APPEAL APPLICATION

Regarding Case Number: DIR-2017-2942-DRB-SPP; CEQA: ENV-2017-2943-CE

Project Address: 1099 Westwood Boulevard; Los Angeles, CA 90024

**Re: Case No. DIR-2017-2942-DRB-SPP; CEQA: ENV-2017-2943-CE
1099 Westwood Boulevard; Los Angeles, CA 90024
Applicant: Artisanal Brewers Collective, LLC (dba Broxton)**

HISTORIC PHOTO
SHOWING ORIGINAL
MULTI-PANED
WINDOW

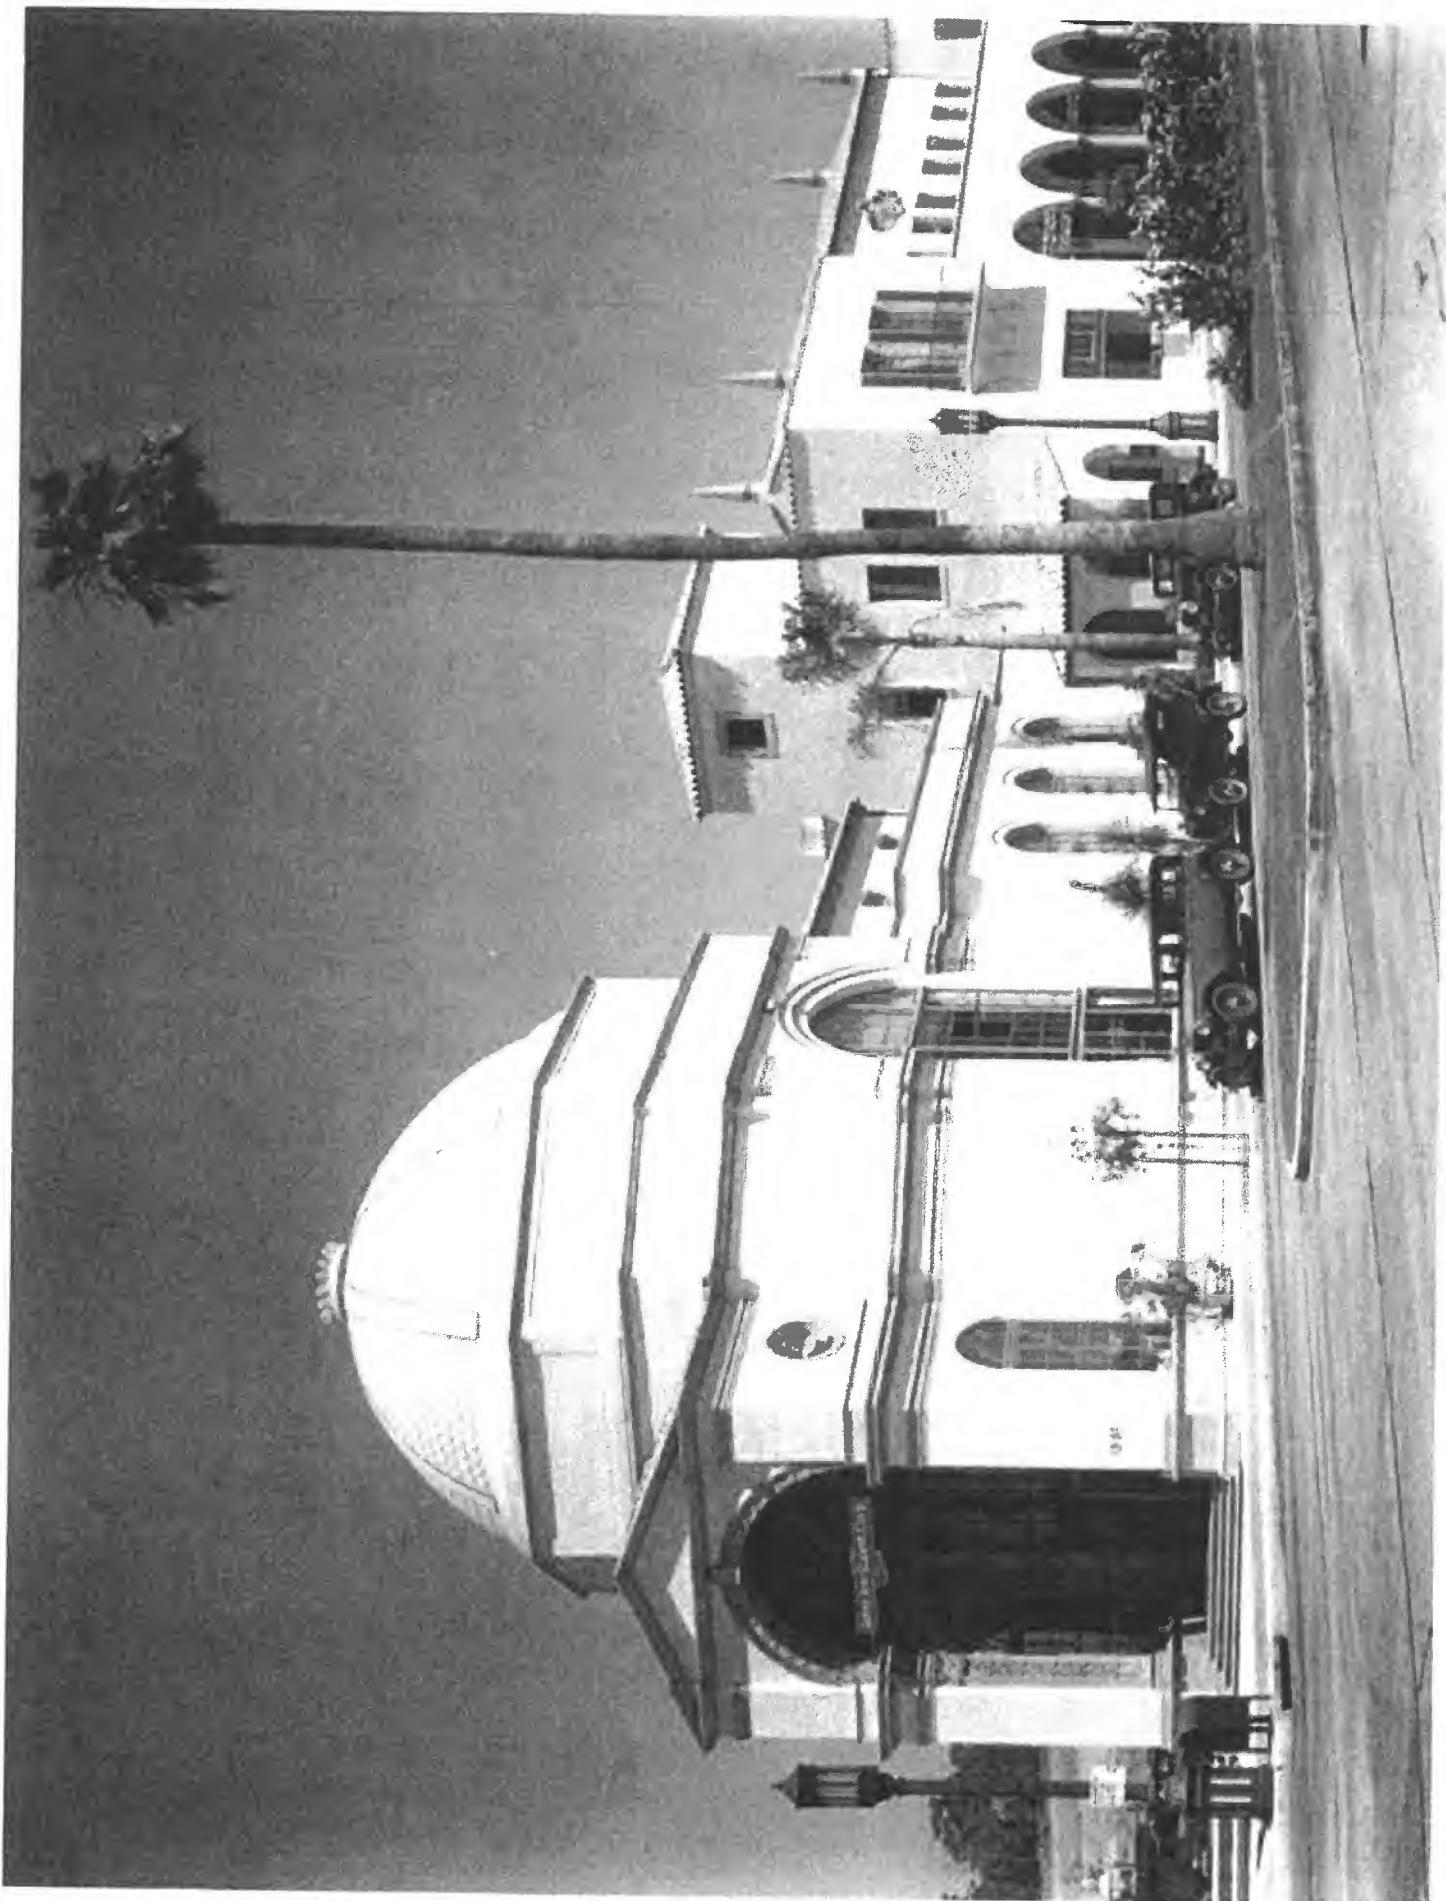
Said new steel multi-paned windows will essentially match the drawing of said plate glass section on Page 15 of the set of plans Applicant initially brought to the WWNC early in 2017 and not the drawing on Page 15 of the set of Plans filed with the DRB this past summer.

EAST ELEVATION
15

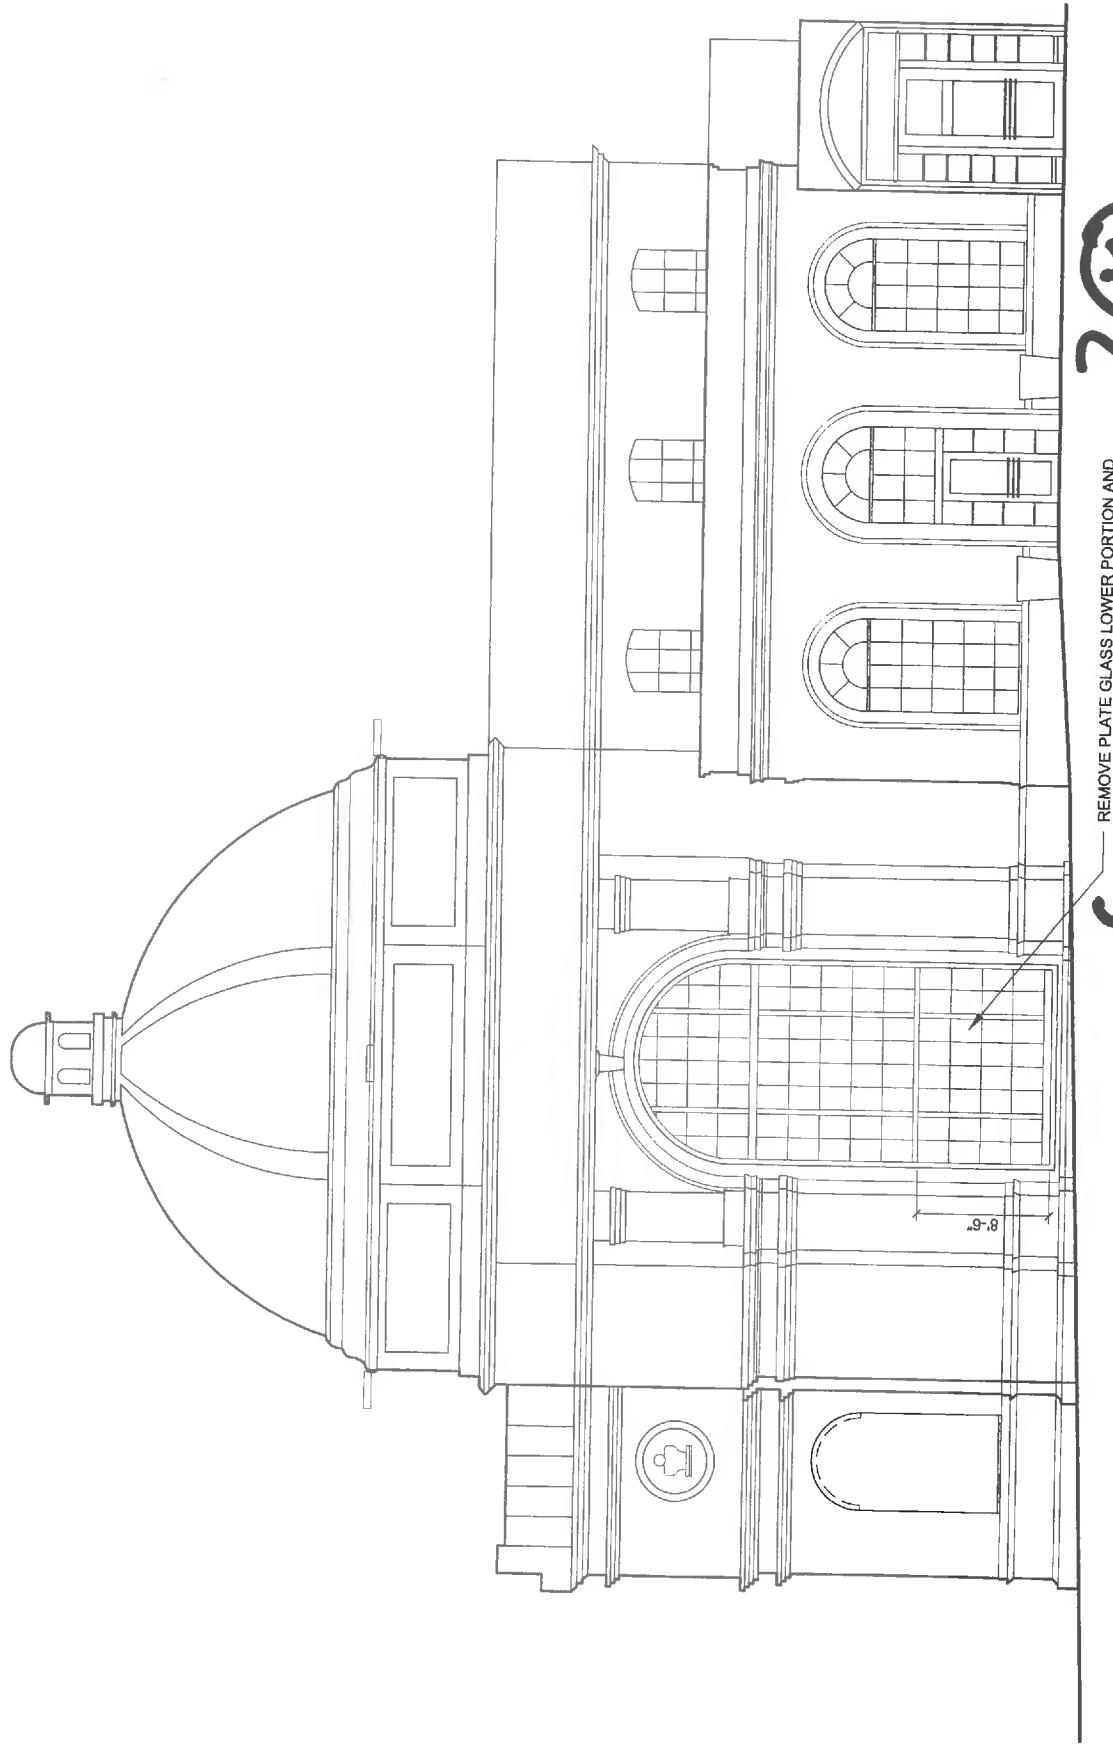
In fact, on Sheet 15 (“East Elevation”) in the Plans drawn by Anthony Eckelberry architect, which Plans were most recently submitted by the Applicant’s representative, Margaret Taylor, to the Westwood Neighborhood Council, these Plans include the following Note (written in ALL CAPS):

“REMOVE PLATE GLASS LOWER PORTION AND REPLACE WITH NEW STEEL STOREFRONT TO MATCH EXISTING”.

EAST ELEVATION

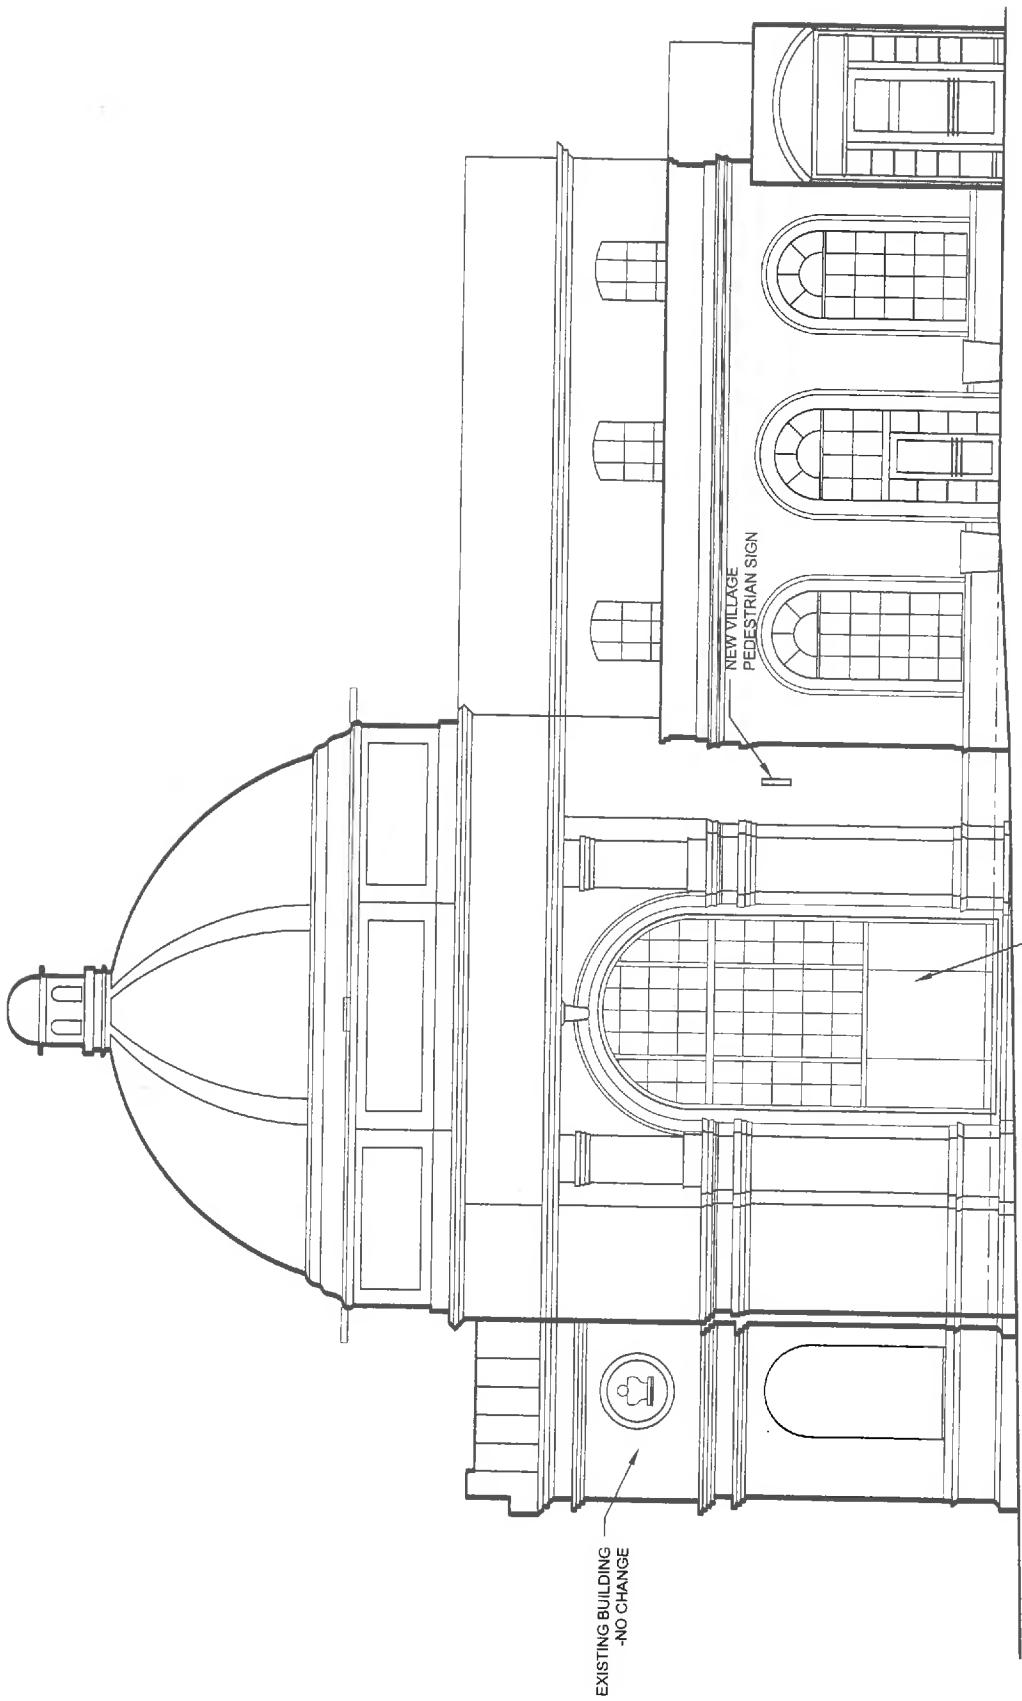
However, after receiving approval from the Westwood Neighborhood Council, the Applicant SWITCHED THEIR SET OF PLANS, and submitted a DIFFERENT SET OF PLANS to the Planning Department, which

altered set removed ALL plans, drawings, renderings, and notes referencing the repair and restoration of this character-defining feature shown to the Neighborhood Council.

ALTERED SET OF PLANS SUBMITTED BY APARTMENT TO
Planning's Office Thruout, drawings NOT & Details
contary to with this plan to Westwood N.C.
Exhibit 12 2012 Pictorial Book
